TRANS/WP.29/GRSG/2005/20
25 July 2005

World Forum for Harmonization of Vehicle Regulations (WP.29)

PROPOSAL FOR DRAFT 02 SERIES OF AMENDMENTS TO REGULATION No. 107

(M2 and M3 vehicles)

"Figure 1 1/

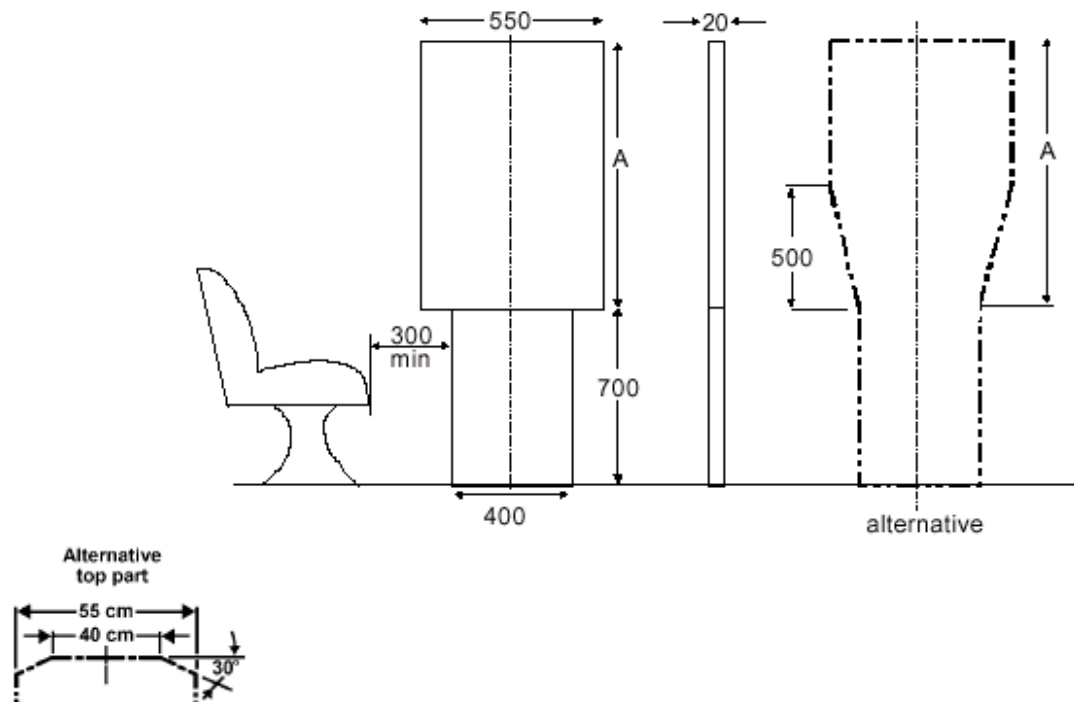
Figure 1, amend to read:

1/ "Alternative top part" diagram should be revised before publication to refer to "550 mm" and "400 mm" as appropriate."

Classes I, II and III: A = 1100 mm

Classes A and B: A = 950 mm

Number of passengers	≤ 22 (1)		> 22		
	A	B	I	II	III
Classes					
Dimension A (mm)	950	700	1100	950	850
Total height of dual panel	1650	1400	1800	1650	1550

"Figure 5

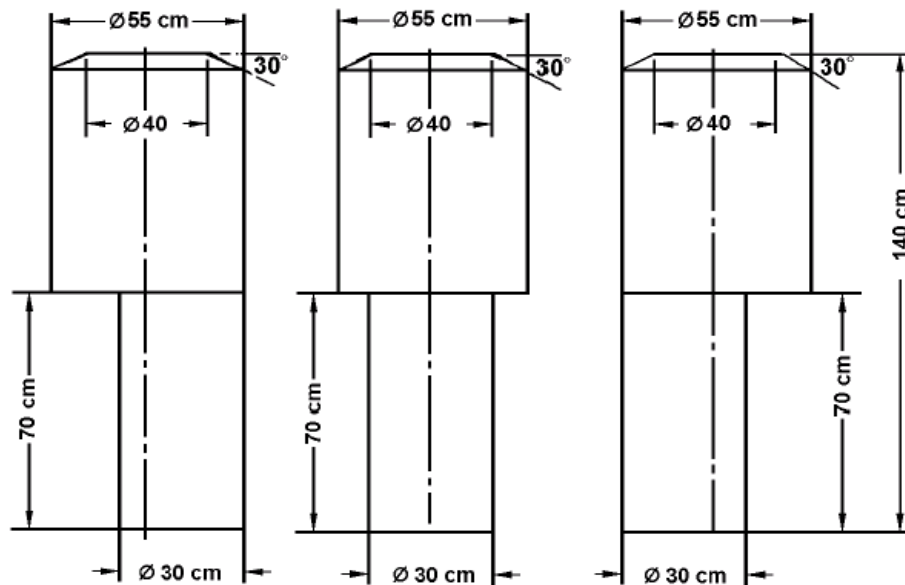
Figure 5, amend to read:

[Editorial note: In final version, units should be changed to mm to align with text]"

"Figure 6
GANGWAYS
(see Annex 3, paragraph 7.7.5.)

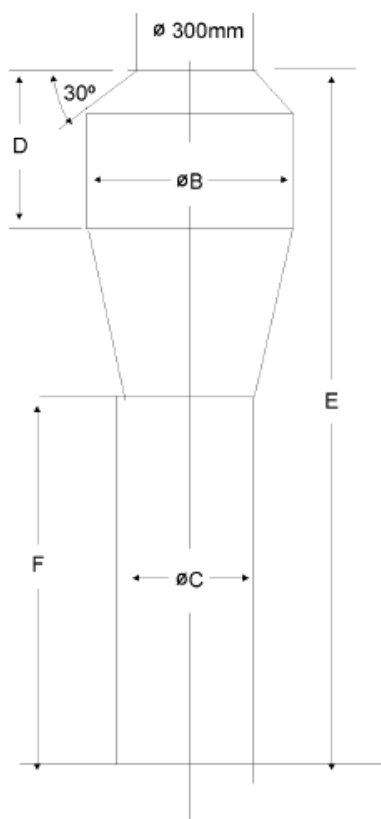
Figure 6, amend to read:

Single deck						
Class		B (mm)	C (mm)	D (mm)	E (mm)	F (mm)
A		550	350	500 (<u>4</u> /)	1900 (<u>4</u> /)	900
B		450	300	300	1500	900
I		550	450 (<u>3</u> /)	500 (<u>4</u> /)	1900 (<u>4</u> /)	900
II		550	350	500 (<u>4</u> /)	1900 (<u>4</u> /)	900
III		450	300 (<u>2</u> /)	500 (<u>4</u> /)	1900 (<u>4</u> /)	900
Double deck						
I	LD	550	450 (<u>3</u> /)	500	1800 (<u>1</u> /)	1020 (<u>1</u> /)
	UD	550	450(<u>3</u> /)	500	1680	900
II	LD	550	350	500	1800 (<u>1</u> /)	1020 (<u>1</u> /)
	UD	550	350	500	1680	900
III	LD	450	300 (<u>2</u> /)	500	1800 (<u>1</u> /)	1 020 (<u>1</u> /)
	UD	450	300 (<u>2</u> /)	500	1800	900

- (1/) The overall height of the gauging device may be reduced (by reducing the height of the lower cylinder):
- (a) from 1800 mm to 1680 mm in any part of the gangway of the lower deck to the rear of a transverse vertical plane situated 1500 mm forward to the centre of the rear axle (foremost rear axle in the case of vehicles with more than one rear axle),

- (b) from 1800 mm to 1770 mm in the case of a service door which is situated forward the front axle in any part of the gangway situated between two transverse vertical planes situated 800 mm forwards and behind the centre line of the front axle.

- (2/) 220mm in the case of laterally movable seats (see paragraph 7.7.5.3).
- (3/) The diameter of the lower cylinder may be reduced from 450 mm to 400 mm in any part of the gangway to the rear of the most forward of the following two planes:

- (a) a transverse vertical plane situated 1.5 m forward of the centre line of the rear axle (foremost rear axle in the case of vehicles with more than one rear axle); and

- (b) a transverse vertical plane situated at the rear edge of the rearmost service door in between the axles.
- For the purpose of the above, each rigid section of an articulated vehicle shall be considered separately.

- (4/) The height of the upper cylinder and herewith the overall height may be reduced by 100 mm in any part of the gangway to the rear of:
- (a) a transverse plane situated 1.5 m forward of the centre line of the rear axle (foremost rear axle in the case of vehicles with more than one rear axle), and

- (b) a transverse vertical plane situated at the rear edge of the service door or of the rearmost service door if there are more than one service door."

"Figure 8

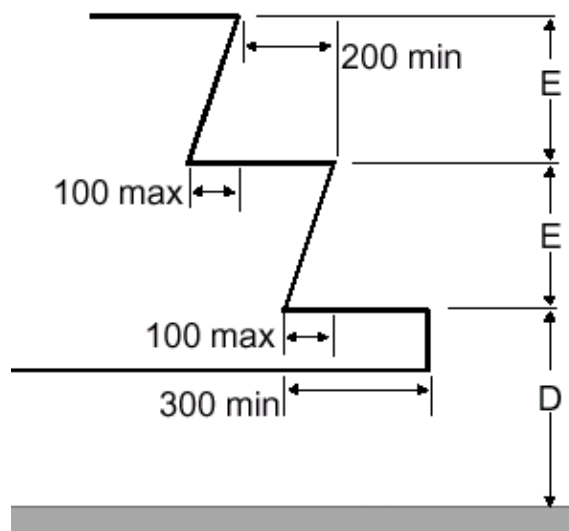
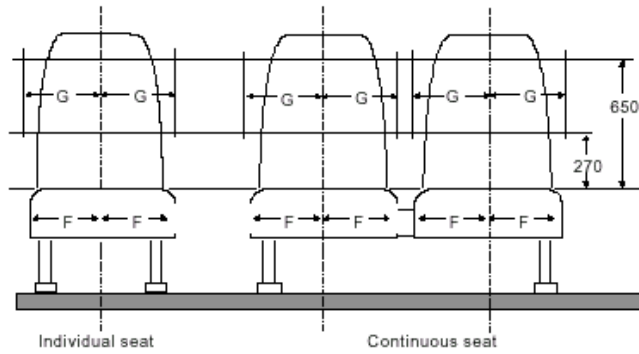
Figure 8, amend to read:

Classes		I & A	II, III and B
First step from ground 'D'	Max. height (mm)	340 (1)	380 (1)(2)(5)
	Min. depth (mm)	300 (*)	
Other steps 'E'	Max. height (mm)	250 (3)	350 (4)
	Min. height (mm)	120	
	Min. depth (mm)	200

- (*) 230 mm for vehicles having a capacity not exceeding 22 passengers.
- (1) 700 mm in the case of an emergency door.
1500 mm in the case of an emergency door in the upper deck of a double deck vehicle.
850 mm maximum in the case of an emergency door in the lower deck of a double-deck vehicle.
- (2) 430 mm in the case of a vehicle with solely mechanical suspension.
- (3) 300 mm in the case of steps at a door behind the rearmost axle.
- (4) 250 mm in gangways for vehicles having a capacity not exceeding 22 passengers.
- (5) For at least one service door; 400 mm for other service doors.

Note: 1. At a double doorway the steps in each half of the access passage shall be treated separately.
2. E need not be the same for each step."

Figure 9A

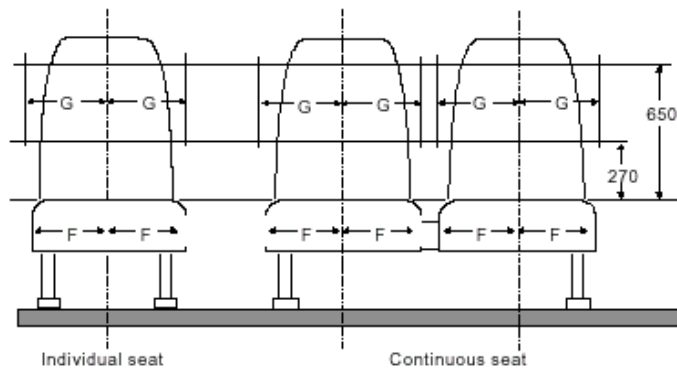
Figures 9 and 9A, amend to read:

G (mm) min	
F (mm) min	Continuous seats	Individual seats
200	200	200

"Figure 15

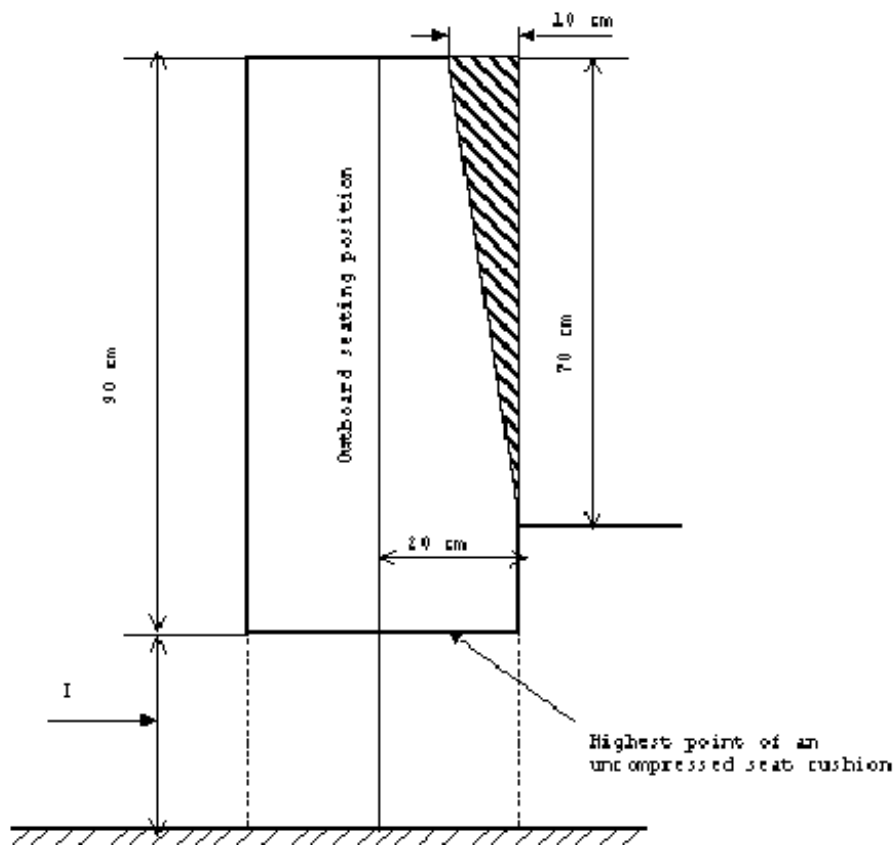
Figure 15, amend to read:

[Editorial note: In final version, dimensions on diagram should be converted to mm]"

I (mm)
400 to 500
(for classes A, B, I and II min 350 mm at wheel arches and engine compartment(s))

"Figure 20

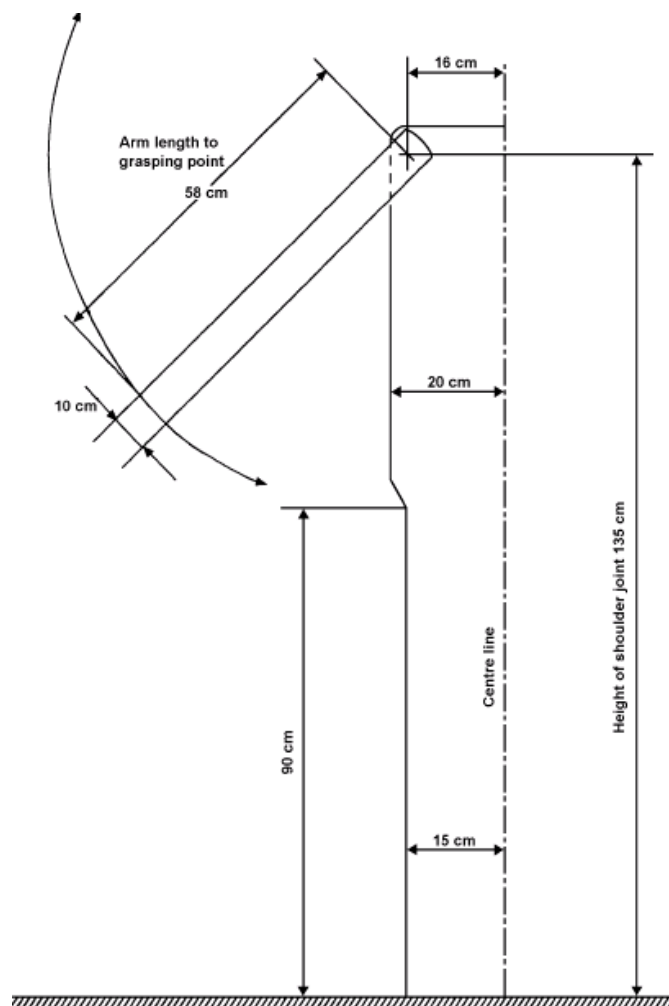
Figure 20, amend to read:

Thickness: 2cm."

"Figure 24

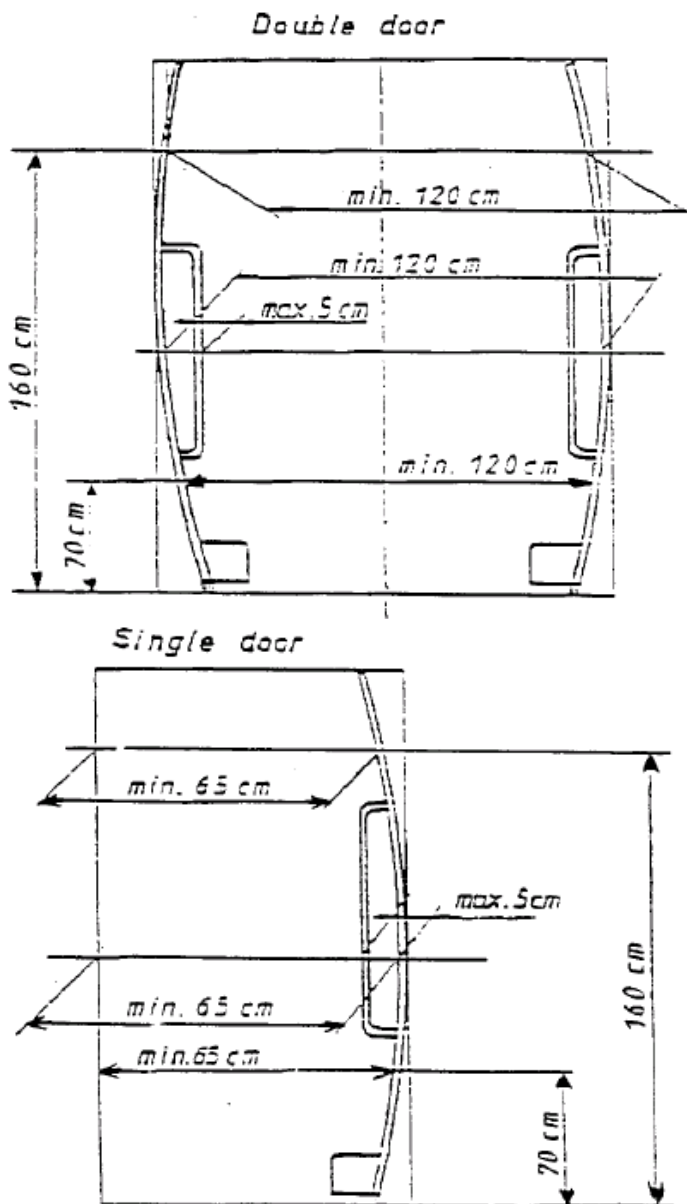
Insert new figures 24 to 26, to read:

"7.6.3.1. The several kinds of exit shall have the following minimum dimensions of free access (see also Annex 4, Figure 24):

Class I	Class II and III	Remarks
Service door	Door Aperture	Height (mm)	1800	1650	-
		Width (mm)	single door: 650 double door: 1200		This dimension may be reduced by 100 mm when the measurement is made at the level of the handholds. The required width of free access shall be ensured in the height of 700 to 1600 mm related to the level of the first step (see Annex 3, figure 24).
Emergency Door		Height (mm)	1250		-
		Width (mm)	550		
Emergency window	Area: (mm ²)		400 000		It shall be possible to inscribe in this area a rectangle 500 mm x 700 mm.
Emergency window situated in the rear face of the vehicle, if the manufacturer does not provide an emergency window of the minimum dimensions prescribed above.			It shall be possible to inscribe in the emergency window aperture a rectangle 350 mm high and 1550 mm wide. The corners of the rectangle may be rounded to a radius of curvature not exceeding 250 mm.
